March 14, 1996

RE: Workplan Addendum
Shell Service Station
WIC #204-6852-1404
1784 150th Avenue
San Leandro, California
WA Job #81-0422-80

Figure 2. Proposed Soil Vapor Sample Locations - Shell Service Station WIC #204-6852-1404, 1784 150th Avenue, San Leandro, California

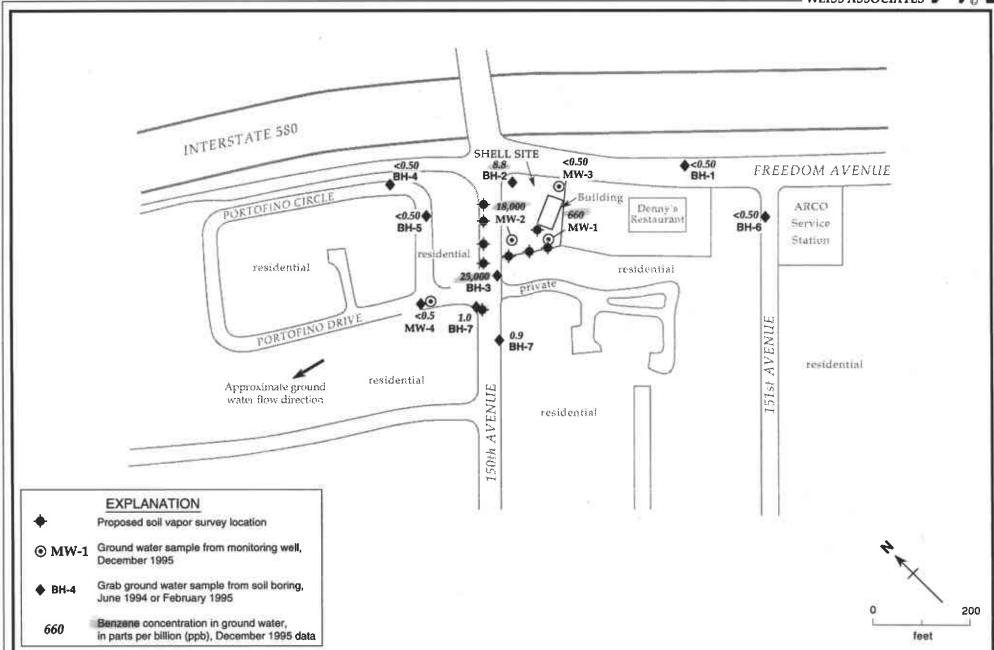
Sample Locations: Our recommended SVS sample locations are presented in the attached Figure 1. Shell has opted to move the sample locations originally proposed on the property adjacent to the Shell station to the station property (Figure 2). Shell will then avoid the potentially time-consuming process of securing a right-of-entry agreement with the adjacent property owner.
